Government of the District of Columbia

Department of Transportation

MEMORANDUM

SUBJECT: ZC Case No. 20-34 – 300 12th Street SW (Cotton Annex)

Figure 1 | Site Plan (Source: Gorove Slade, CTR Figure 7, 2/16/21)

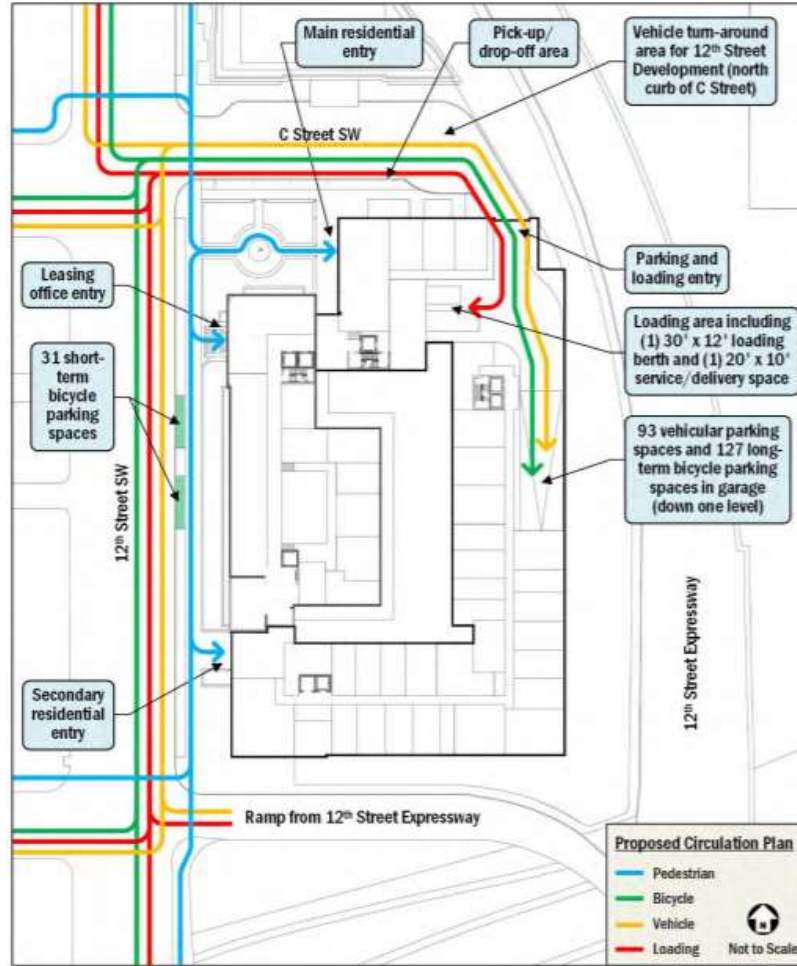
While the preliminary public space plans, shown above in Figure 1, are generally consistent with DDOT standards, there are several considerations that need to be reviewed in greater detail during the public space permitting process:

- DDOT concurs that the existing curb cut on 12th Street SW should be closed and replaced with green space and street trees;
- The proposed curb cut on C Street SW will not need to be reviewed and approved by the Public Space Committee since the street is private;

- Design a curb extension into the roadway reconstruction plans for the south side of private C Street SW at 12th Street (not currently shown on the plans), consistent with the proposal by the other property owner on the opposite side of C street;

- Private C Street should be designed to DDOT standards so that in the future it can be accepted into the DDOT portfolio of public streets;
- Signage should be added at the corner of C Street and 12th Street stating that C Street is private;

- Installation of the missing curb ramps, upgraded substandard curb ramps, and missing high-visibility crosswalks at the intersection of 13th Street and C Street should be included in the Cotton Annex 12th Street SW streetscape permit application;

- Balconies on the back side of the property will require public space permits and Federal Highway Administration (FHWA) approval since they are located within 12th Street Expressway right-of-way; and

- Short-term bicycle parking racks should be within 120 feet of the primary building entrance and located within private space or the furnishing/tree zone of public space.

Figure 5 | Existing Pedestrian Network (Source: Gorove Slade 2/16/21 CTR, Figure 28)

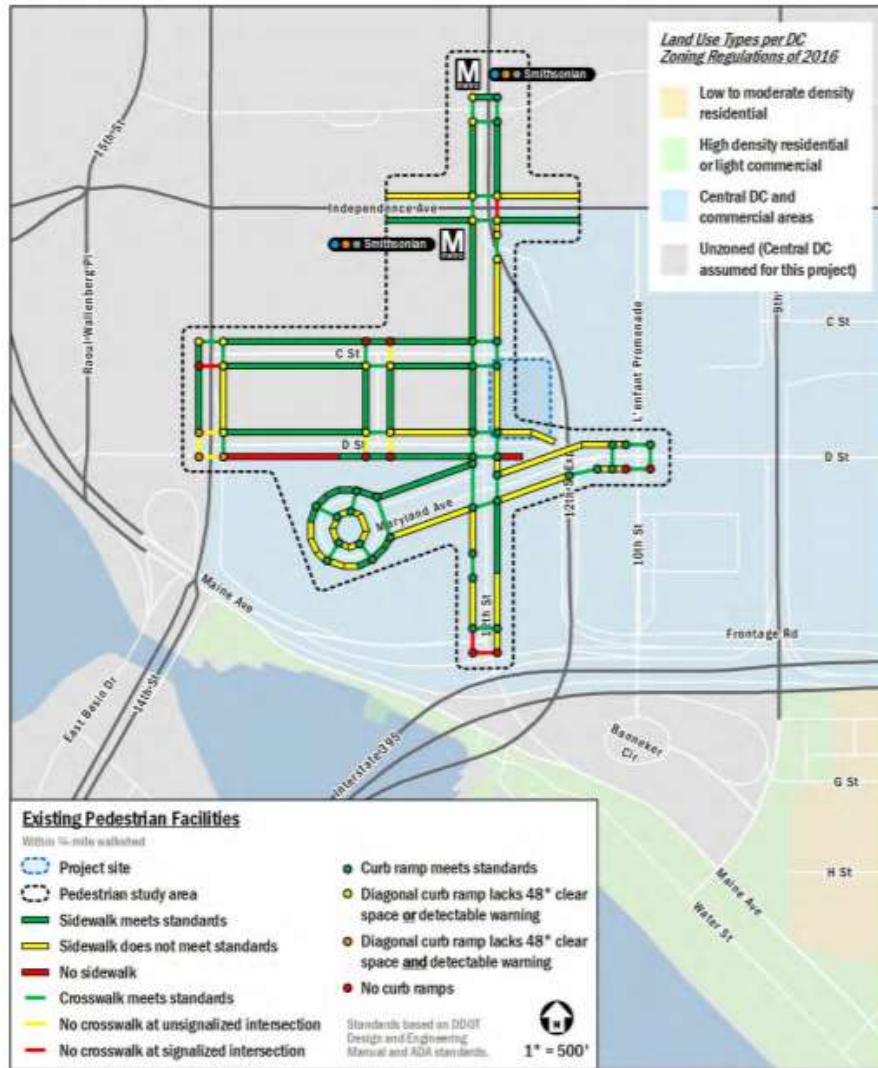
The Applicant’s inventory of existing pedestrian infrastructure, as shown in Figure 5 below, demonstrates that most sidewalks in the immediate vicinity of the site are currently constructed with appropriate widths and include accessible curb ramps. While there are a number of missing or substandard facilities in the broader area, the existing pedestrian network along major walking routes from the site to schools, attractions, and the Metrorail station is generally adequate.

To help offset traffic impacts identified in the CTR, DDOT requests the Applicant install the missing curb ramps and crosswalks and substandard pedestrian facilities at the intersection of C Street and 13th Street SW. Additionally, the Applicant should design a curb extension into their roadway reconstruction plans on the south side of private C Street at 12th Street, consistent with the proposal for the northern half of C Street by the adjacent property owner. DDOT notes that the final design of the curb ramps and crosswalks will occur during public space permitting.

- Add to TDM Plan: Upgrade all substandard and missing curb ramps and install high-visibility crosswalks on all legs of the intersection of C Street and 13th Street SW;

Figure 6 | Existing Bicycle Facilities (Source: Grove Slade 2/16/21 CTR, Figure 30)

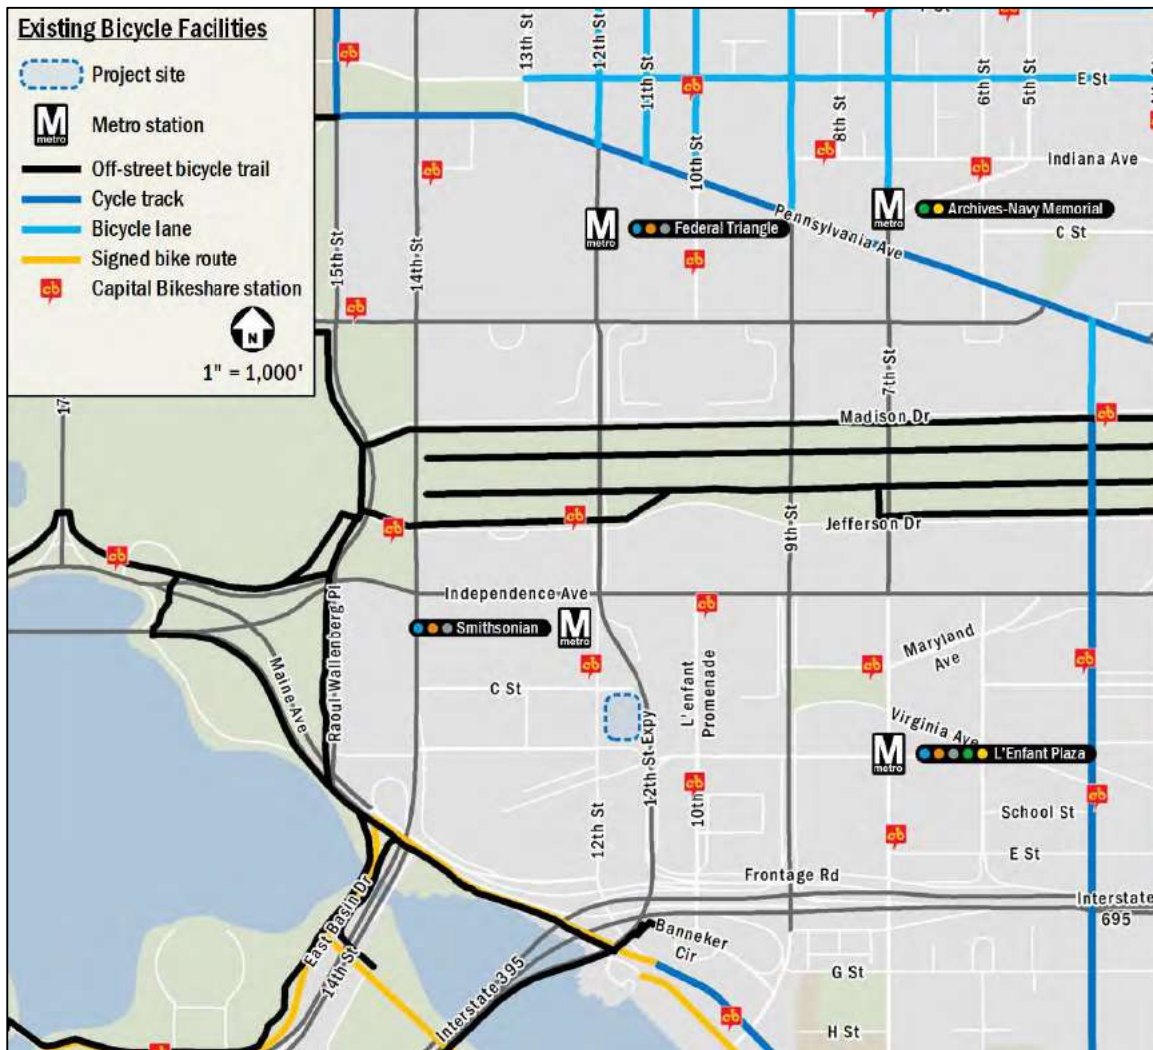
As shown below in Figure 6, there are currently no bicycle lanes within the vicinity of the site. There are several Capital Bikeshare (CaBi) stations within a short-distance of the site, with one station located across 12th Street SW. To help offset the traffic impacts identified in the CTR, DDOT requests the Applicant install two (2) 4-dock expansion plates to this CaBi station. This station is one of the program’s most popular stations and would benefit from the increase in docks to meet the additional potential demand generated by the proposed residential building.

- Add to TDM Plan: Install two (2) 4-dock expansion plates to the existing Capital Bikeshare station at the intersection of C Street at 12th Street SW;
